**AGENDA**  
**PLANNING AND ZONING COMMISSION PUBLIC HEARING**  
**City Hall, 385 South Goliad, Rockwall, Texas**  
**Council Chambers**  
**June 11, 2019**  
**6:00 P.M.**

**CALL TO ORDER**

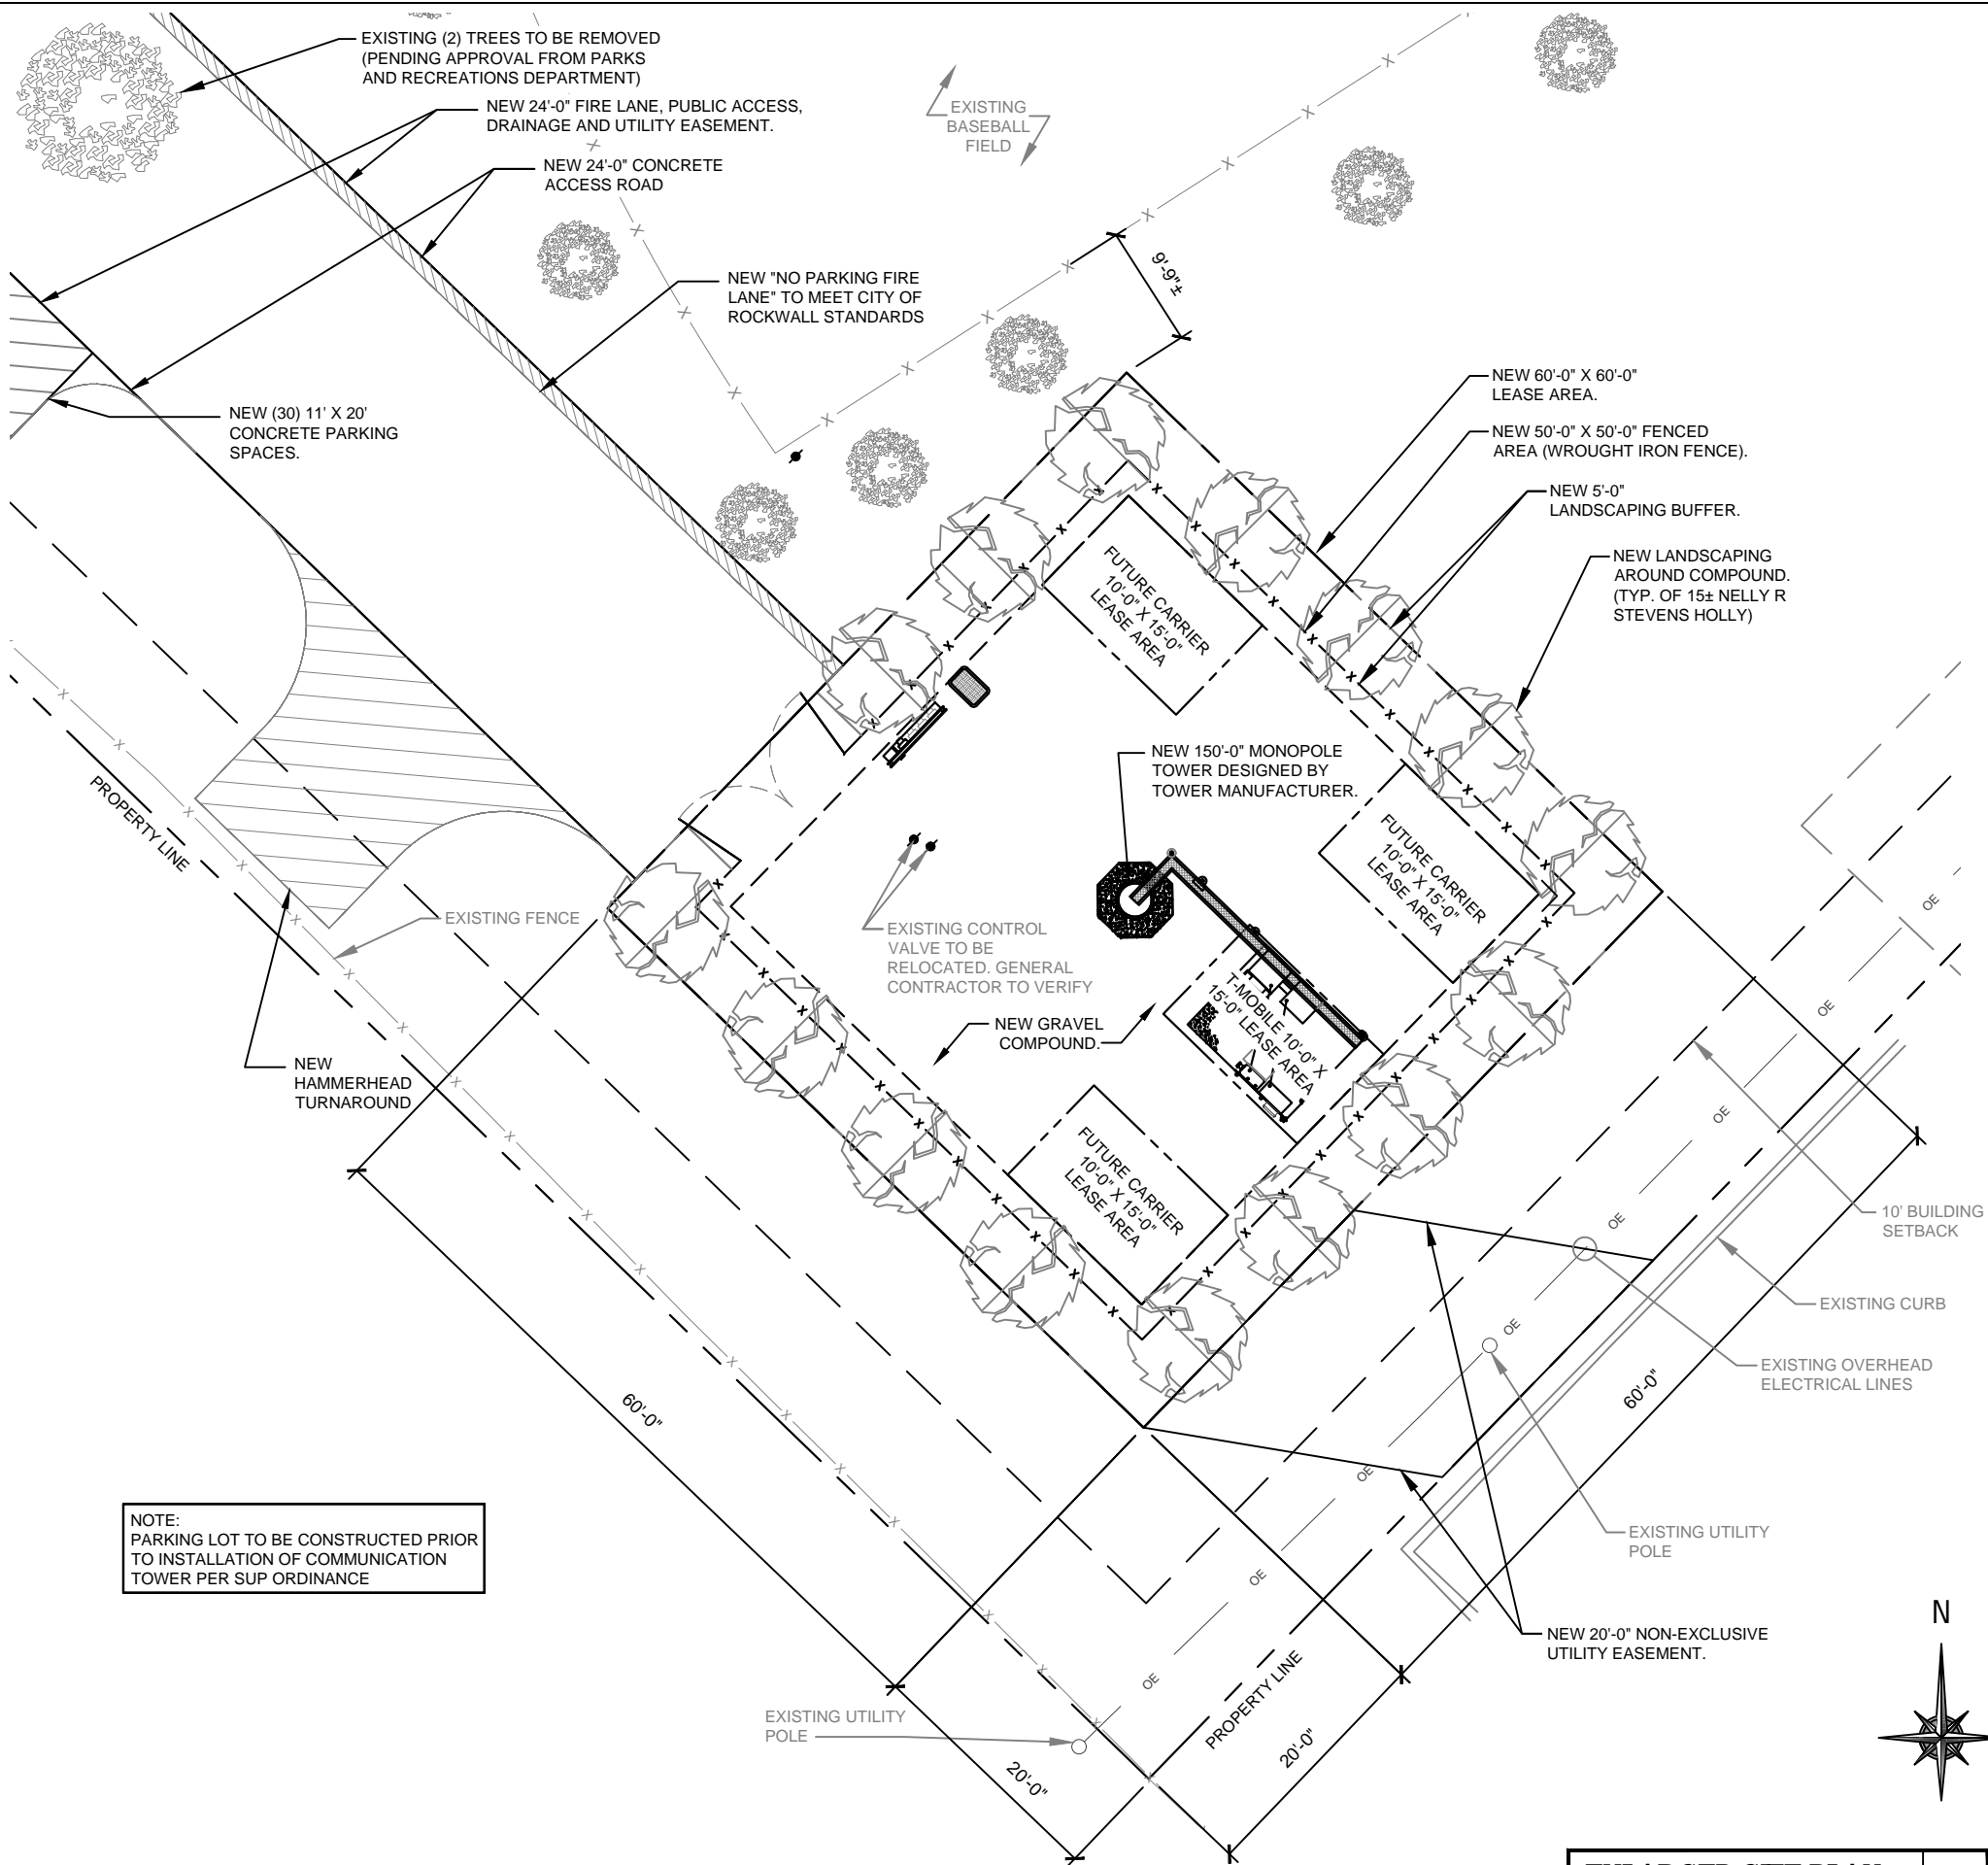
2. THE CONTRACTOR SHALL BE RESPONSIBLE FOR COORDINATING THE WORK OF ALL TRADES AND SHALL CHECK ALL DIMENSIONS. ALL DISCREPANCIES SHALL BE CALLED TO THE ATTENTION OF THE ECO-SITE CONSTRUCTION MANAGER AND/OR ENGINEER AND BE RESOLVED BEFORE PROCEEDING WITH WORK. WHERE THERE IS A CONFLICT BETWEEN DRAWING AND ECO-SITE SPECIFICATIONS, THE ECO-SITE CONSTRUCTION MANAGER SHOULD BE CONTACTED FOR CLARIFICATION.
